# Mountainbrook Heights

Somers, Connecticut

REPORT

**ENVIRONMENTAL REVIEW TEAM REPORT**  
**ON**  
**MOUNTAINBROOK HEIGHTS SUBDIVISION**  
**SOMERS, CONNECTICUT**

List of soil map symbols with their current interpretive name follows:

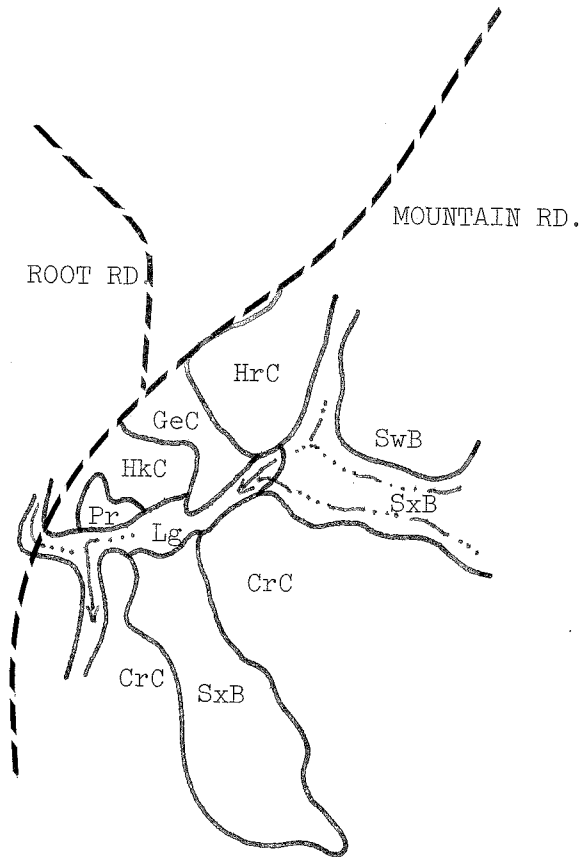
Included in this section are detailed soil map unit names. Map symbols used are those that appear in the published soil survey, however, soil map unit names reflect current concepts and interpretations. In some cases, map units are combined or they were renamed. Also included is a revised soil map to show the approximate boundaries of soils over this parcel.

The attached revised soil map will indicate approximate areas of various soils over this parcel. Wetlands are confined near and around the tributaries that flow into Gillettes Brook. Most of these wet areas were flagged in the field, however, there are wetland areas not flagged along two (2) tributaries which flow to the west and dissect Lot Number 5. These areas should be flagged and indicated on the plot plan map presented to the Town for approval. There are also indications of runoff waters from the northeast, which flow along a stone wall and down a fairly steep grade onto Lots 5 and 6 where it finally dissipates near the primary and reserve area for the septic system of Lot 6. This water will need to be diverted or controlled in order to avoid downslope erosion during and after construction.

The main soil limitations on this site are steep slopes and shallow depths to bedrock. Slopes are as steep as twenty percent (20%) in the northern area of Lot 5. Lots 6, 7, 11, and 15 have slopes of fifteen percent (15%) and greater. Lots 8, 9, 10, and 12 have slopes averaging ten percent (10%). Ledge or bedrock is included to some degree in all soil areas mapped at this site, particularly in the areas of Lots 1, 2, 3, and 4. Strict adherence to an erosion and sediment control plan will be needed to control erosion during construction.
